AC-3801 NOISE BLANKER KIT (641-7105-001)
NOISE BLANKER ASSEMBLY (641-7146-001)
NOISE BLANKER CIRCUIT CARD (638-6800-001)

SERVICE BULLETIN NO 2

IMPROVE PERFORMANCE AND ADD VARIABLE PULSE WIDTH BLANKING

This service bulletin applies to the noise blanker assembly (641-7146-001) with REV B and below.

Noise Blanker Circuit Card (638-6800-001)
Figure 1

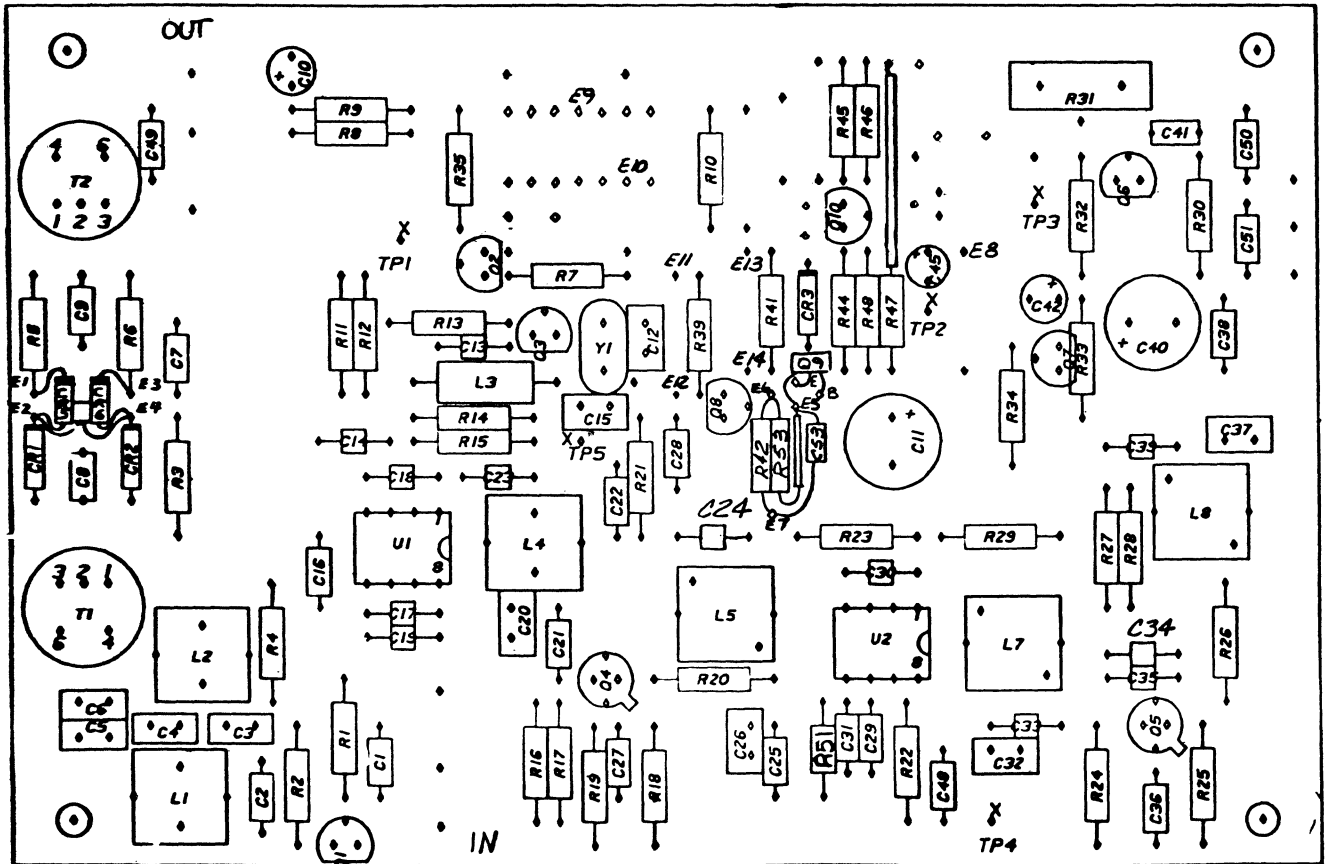
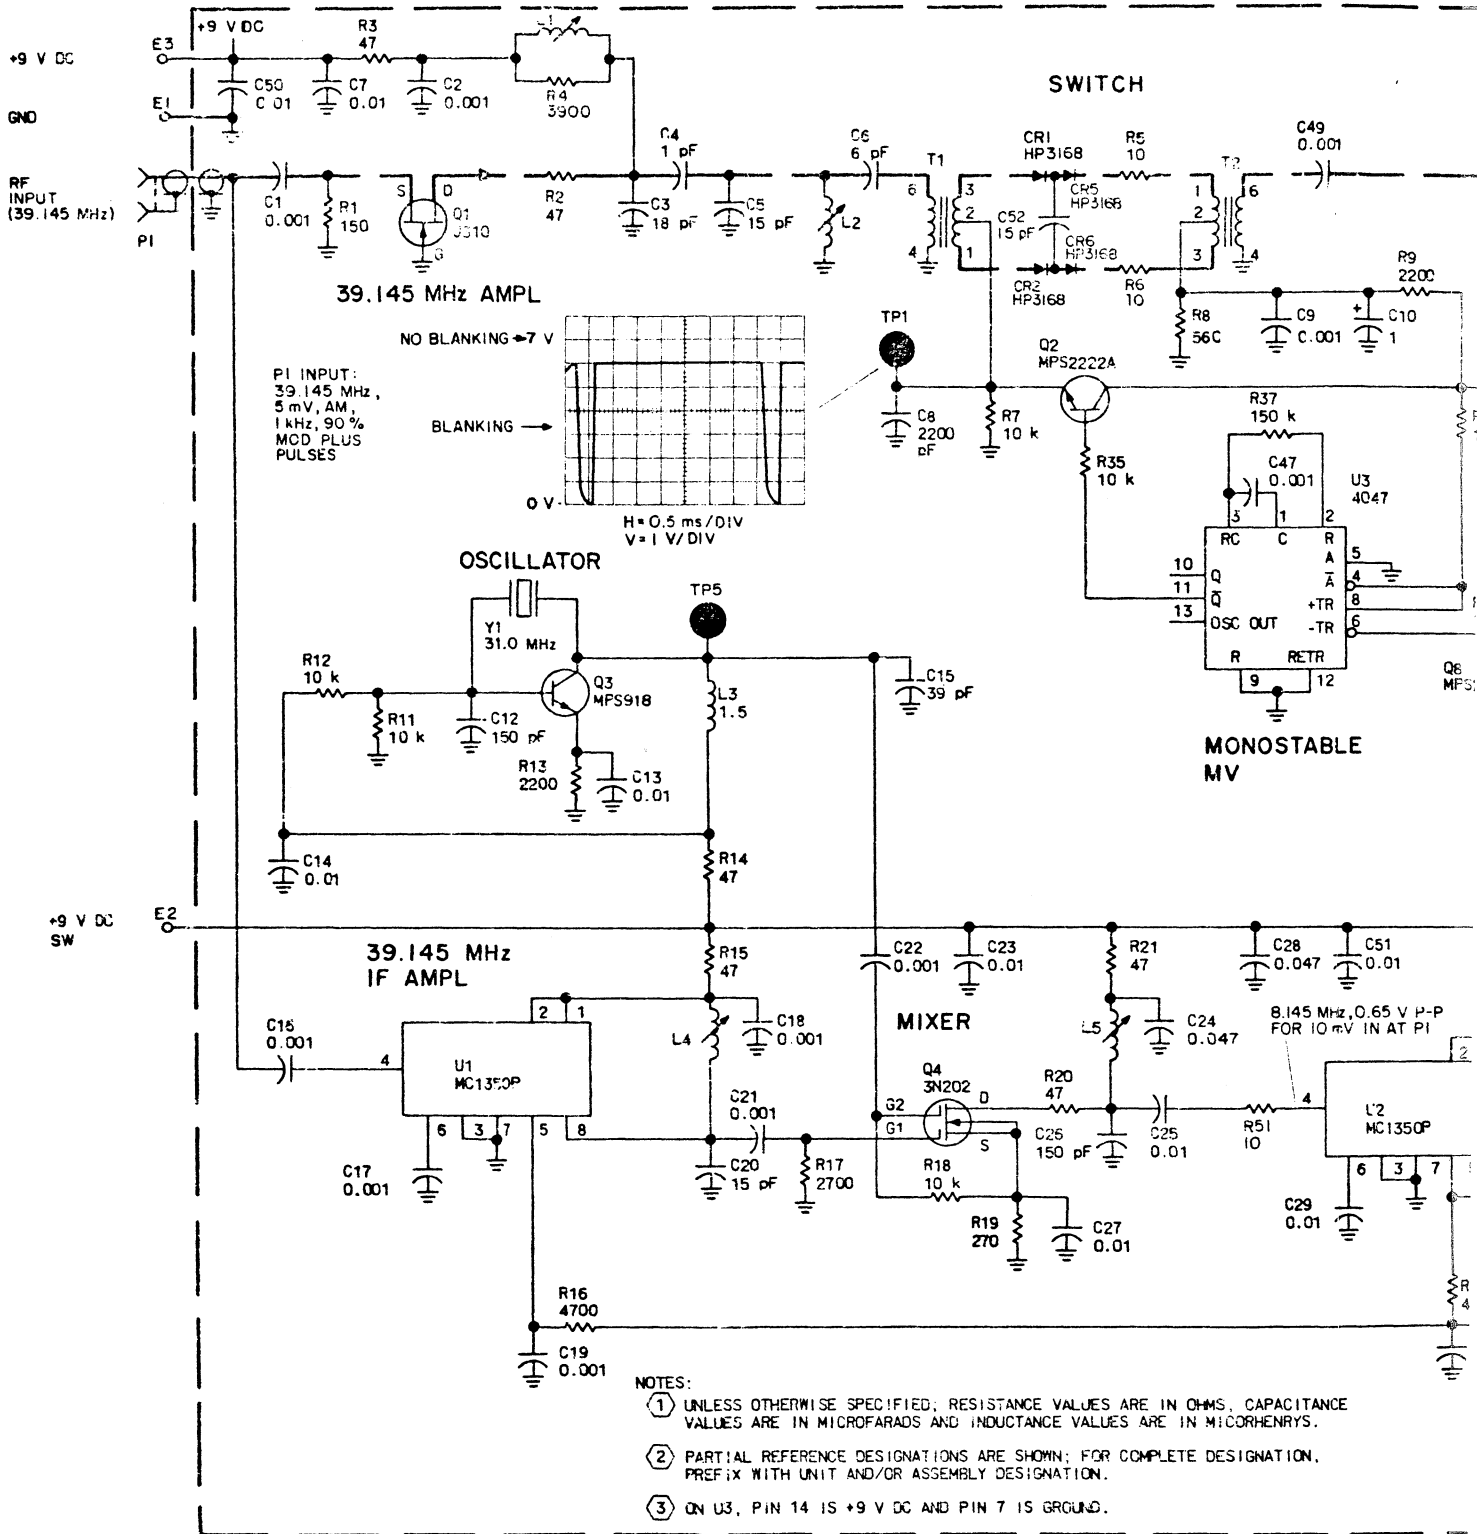
NOTE: Refer to figures 1 and 2 for component locations. Figure 2 is the 638-6800-002 version with all modifications incorporated. Refer to figure 3 for a schematic diagram which includes the changes made by this bulletin.

- F. On the bottom of the card, cut the circuit trace that connects CR1 to R5.
- G. On the bottom of the card, cut the circuit trace that connects CR2 to R6.

- H. Remove the bottom lead of resistor R5 and insert a contact, E1 (372-2656-130), into the vacated hole.
- I. Remove the bottom lead of resistor R6 and insert a contact, E3 (372-2656-130), into the vacated hole.

- J. Remove the cathode end lead of CR1 and insert a contact, E2 (372-2656-130), into the vacated hole.
- K. Remove the cathode end lead of CR2 and insert a contact, E4 (372-2656-130), into the vacated hole.

- L. Connect HP 3168 diode CR5 (353-3733-010) between E1 (cathode) and E2 (anode).
- M. Connect HP 3168 diode CR6 (353-3733-010) between E3 (cathode) and E4 (anode).

- N. Connect 15-pF capacitor C52 (912-4141-130) between E2 and E4.
- O. Remove 5-k Ω potentiometer R31 and replace it with a 50-k Ω pot (376-0274-090).
- P. Remove capacitor C41 and replace it with a 0.001- μ F capacitor (913-4018-000).

- Q. Remove coil L6 and replace it with 10- Ω resistor R51 (745-0677-000).
- R. On the bottom of the card, cut the circuit trace that connects R42 to Q9-C.

- S. Remove the collector lead of Q9 and insert contact E5 (372-2656-130) into the vacated hole.

- T. Connect the collector lead of Q9 to contact E5.
- U. Remove 4.7-k Ω resistor R42 and install contacts E6 and E7 (372-2656-130) into the vacated hole.
- V. Install new 10-k Ω resistor R42 (745-0785-000) between contacts E6 and E7.
- W. Install 10-k Ω resistor R53 (745-0785-000) from E6 to E5. Use insulation sleeving (152-1603-000) on the lead that connects to E5.
- X. Connect 0.01- μ F capacitor C53 (913-3331-020) from E7 to E5.
- Y. Remove and discard the following components:

- Z. Install new 47-k Ω resistor R47 (745-0809-000) as shown in figure 2 with sleeving (152-1603-000) on one lead.
- AA. Remove 150- Ω resistor R41 and replace it with a new 10- Ω resistor (745-0677-000).
- AB. Remove 4.7-k Ω resistor R44 and replace it with a new 22-k Ω resistor (745-0797-000).
- AC. Remove 15-k Ω resistor R48 and replace it with a new 220-k Ω resistor (745-0833-000).
- AD. Remove 220- Ω resistor R46 and replace it with a new 6.8-k Ω resistor (745-0779-000).

Schematic Diagram
Figure 3 (Sheet 1 of 2)

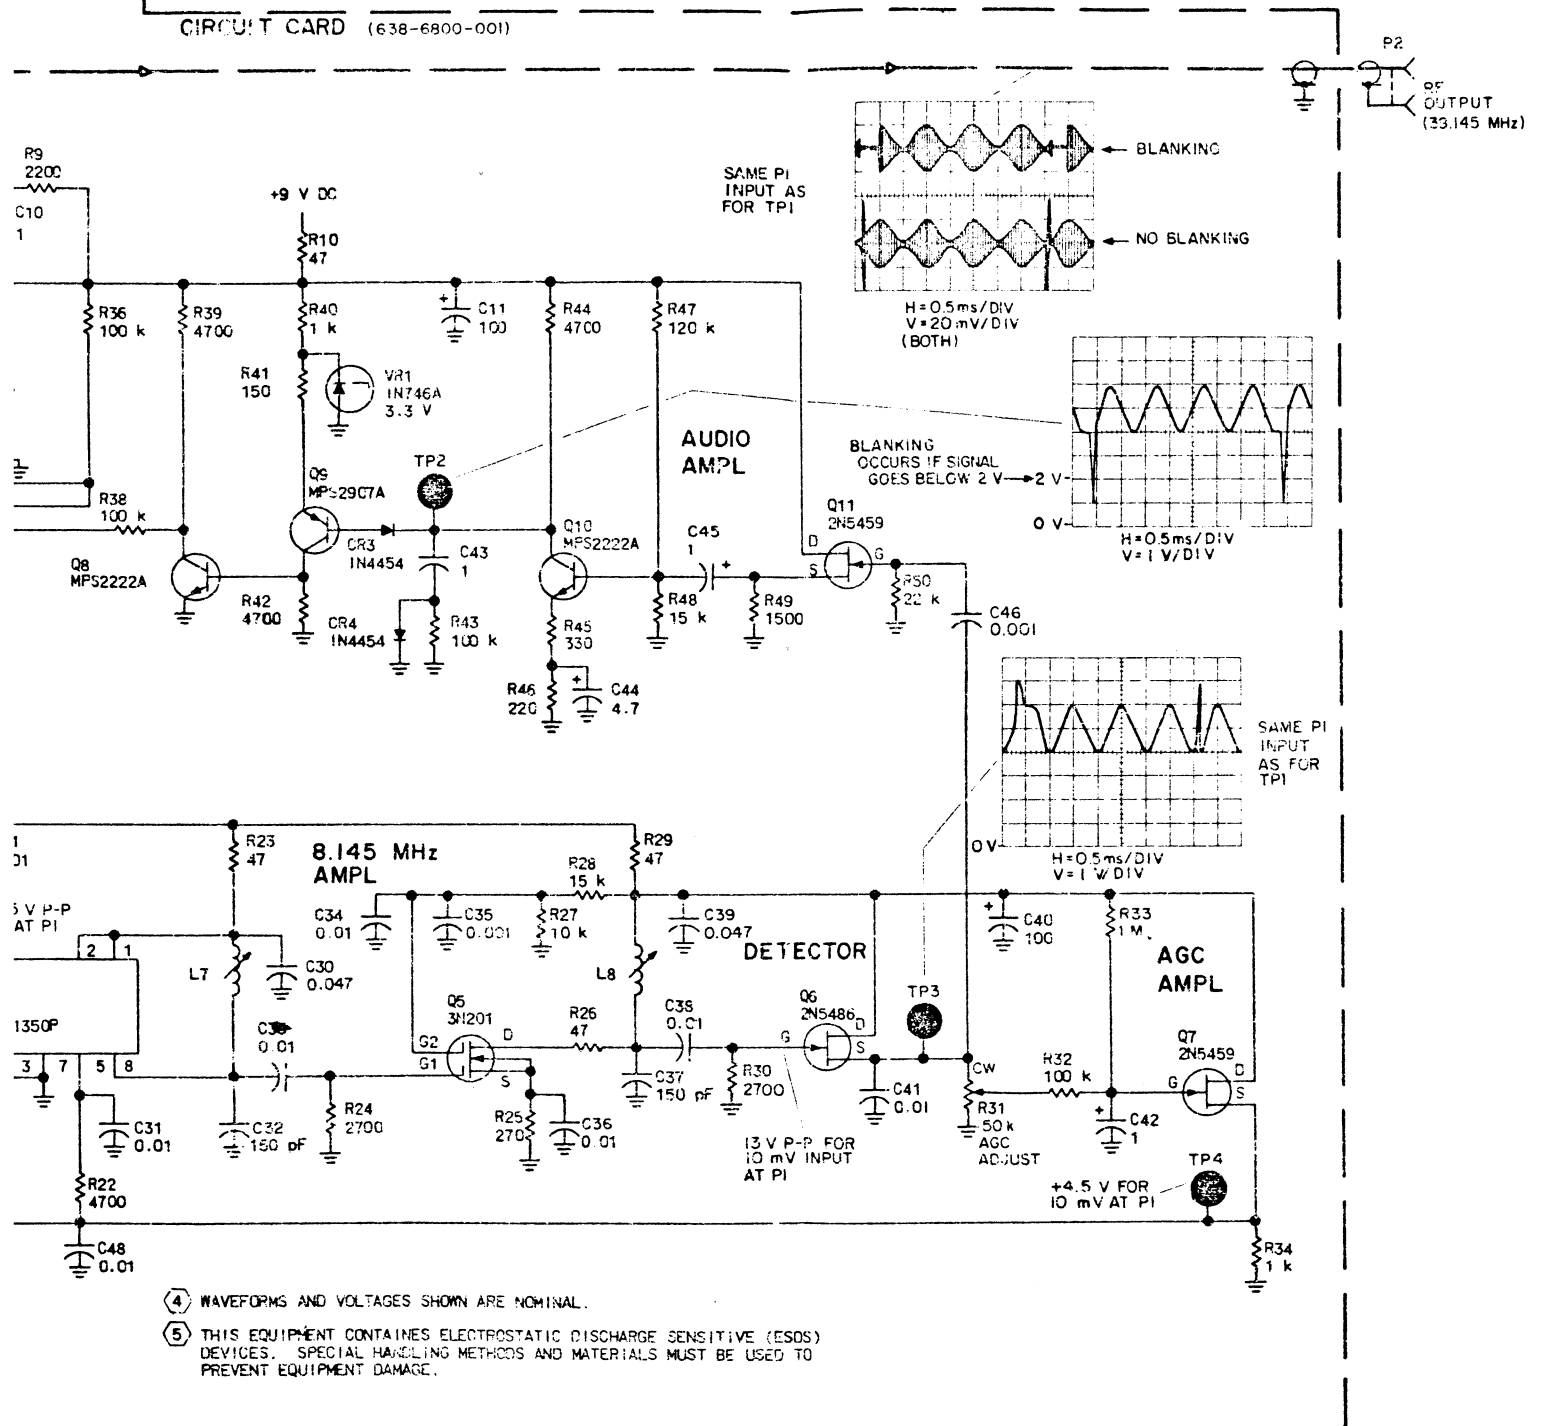
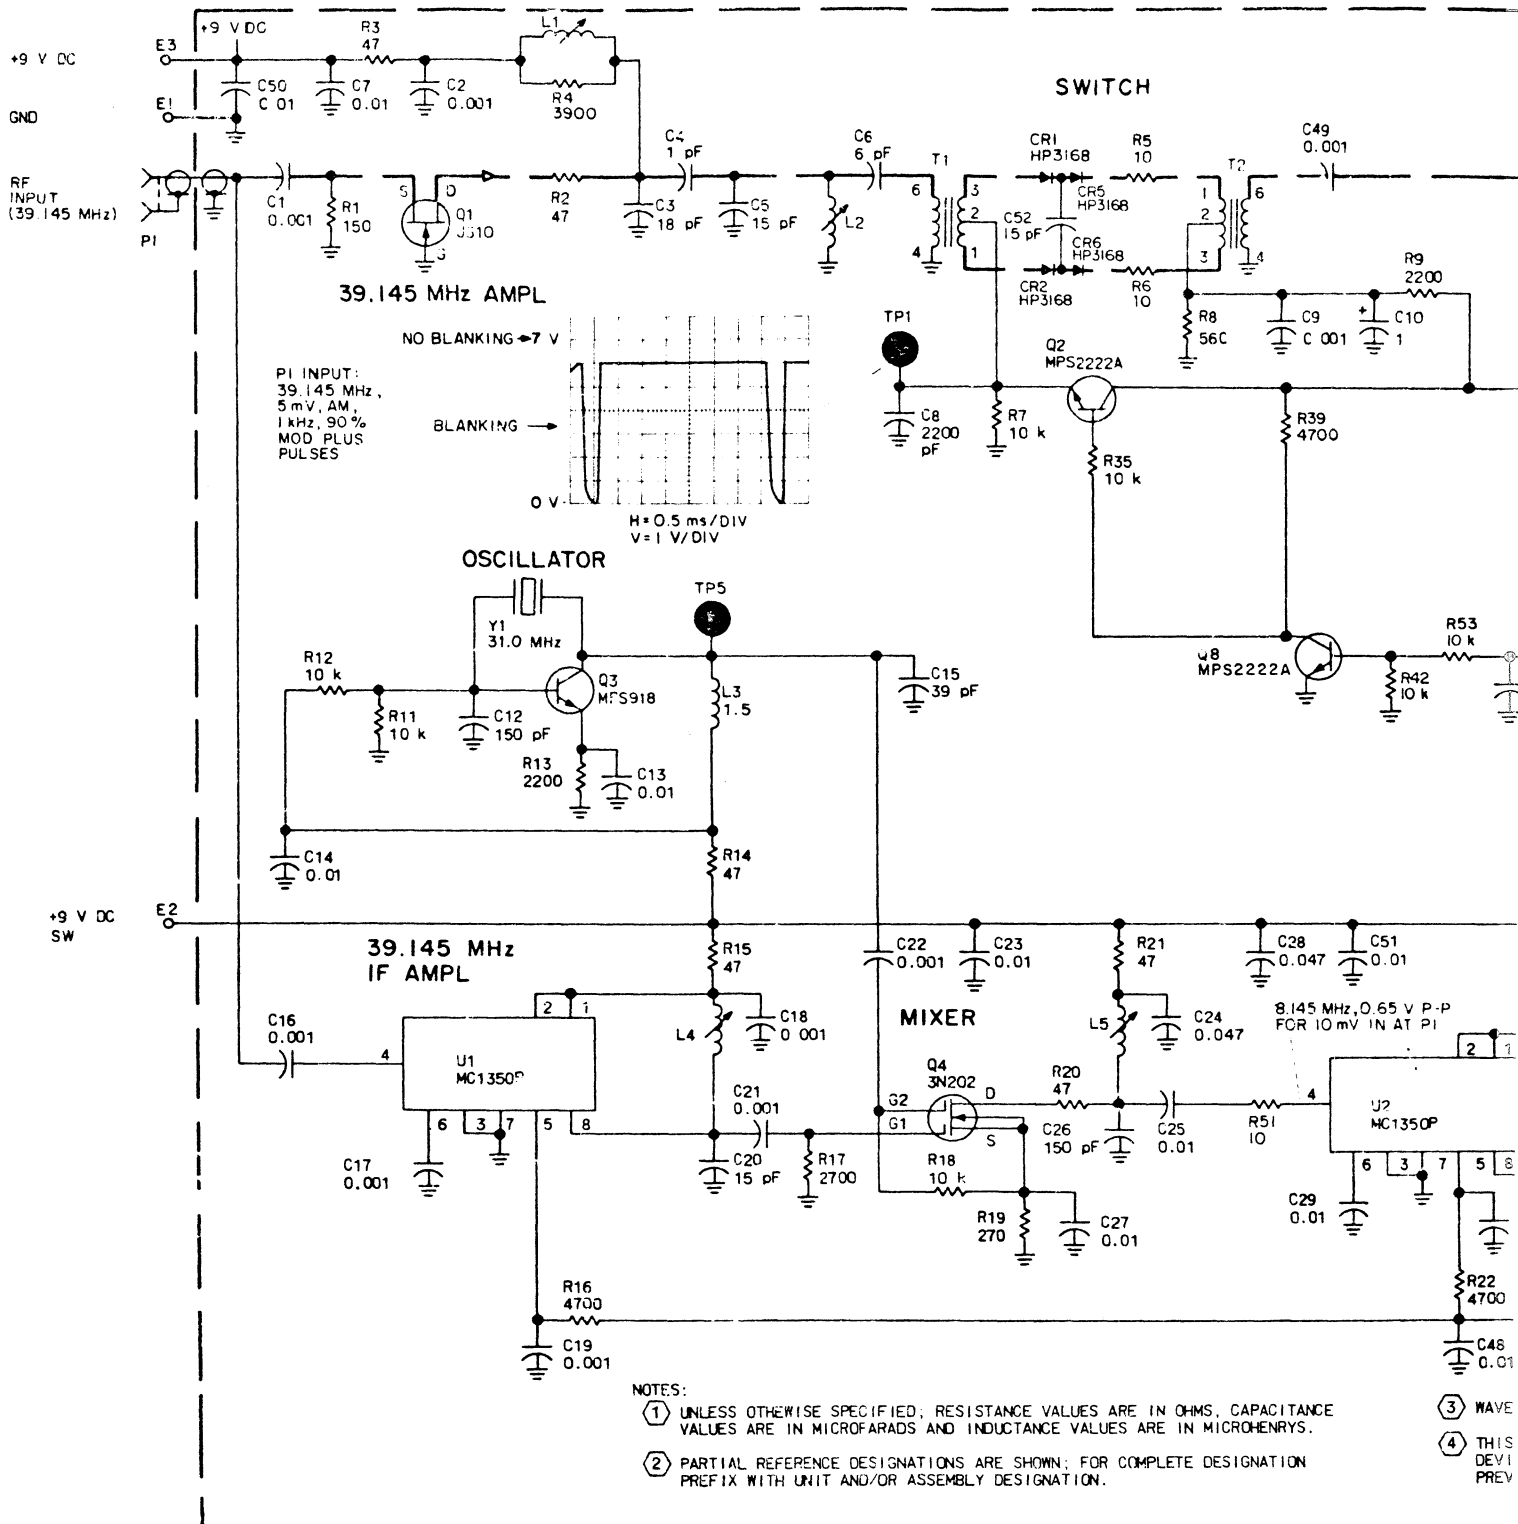
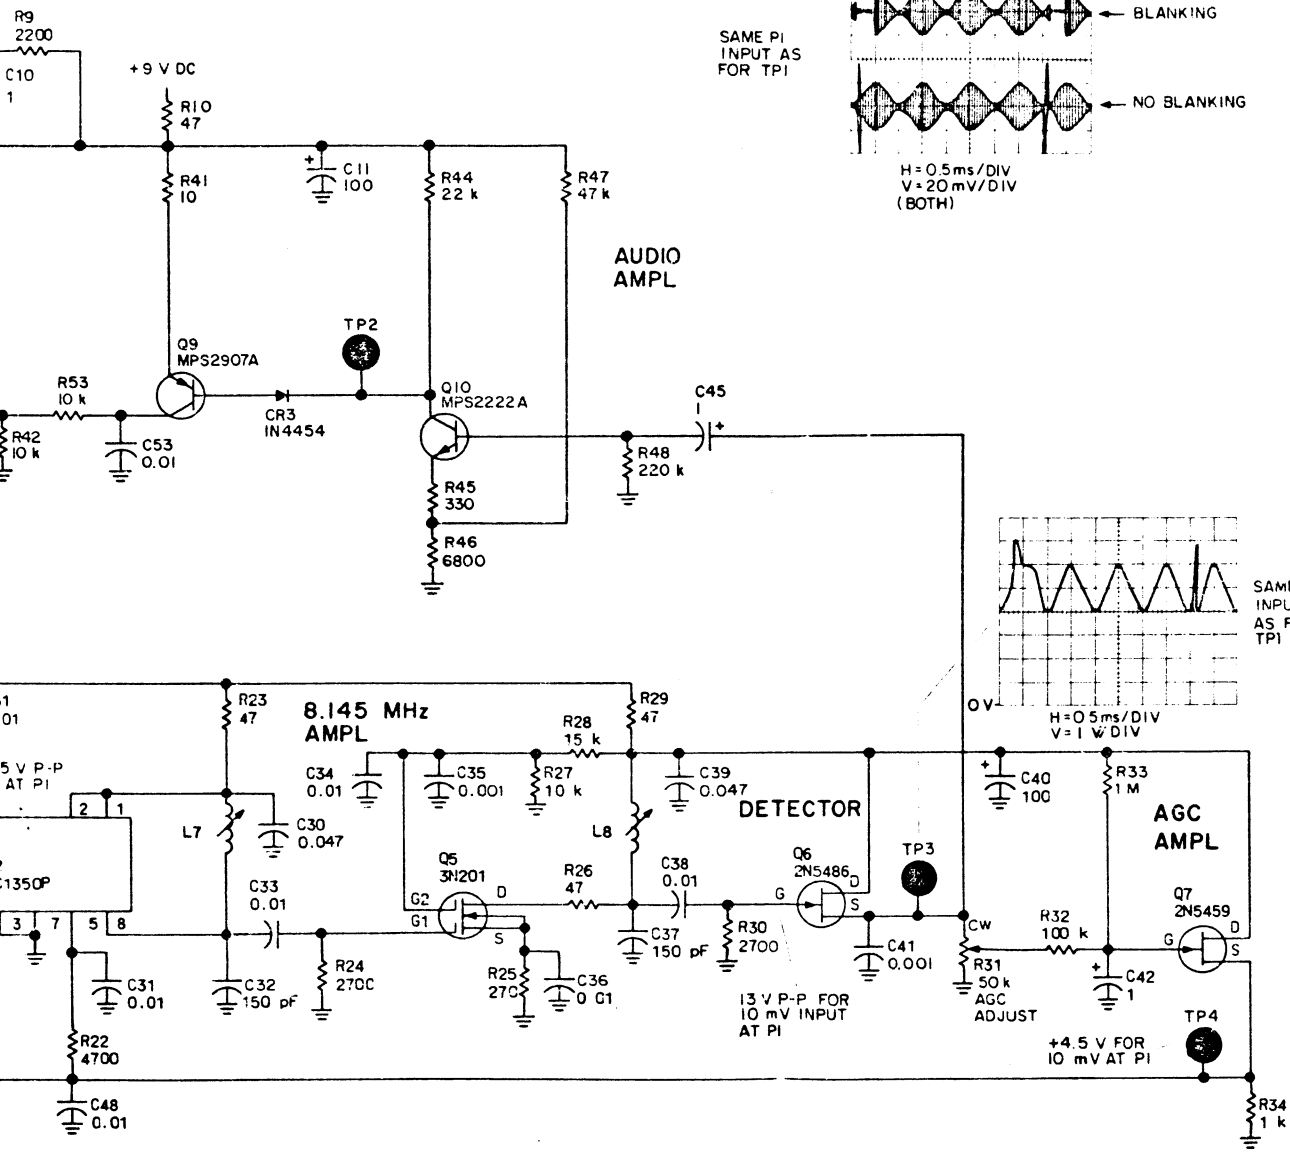
This modification will improve discrimination between sharp noise pulses and voice peaks. This will allow the gain to be set lower and still reduce noise with minimum distortion. This revision also modifies the circuit to produce variable pulse blanking widths which will make the noise blanker effective against HF pulse radar systems.

The change consists of adding two diodes, two capacitors, and one resistor, changing the value of seven resistors and one capacitor, replacing one coil with a resistor, and deleting seven resistors, four capacitors, two diodes, one integrated circuit, and one transistor.
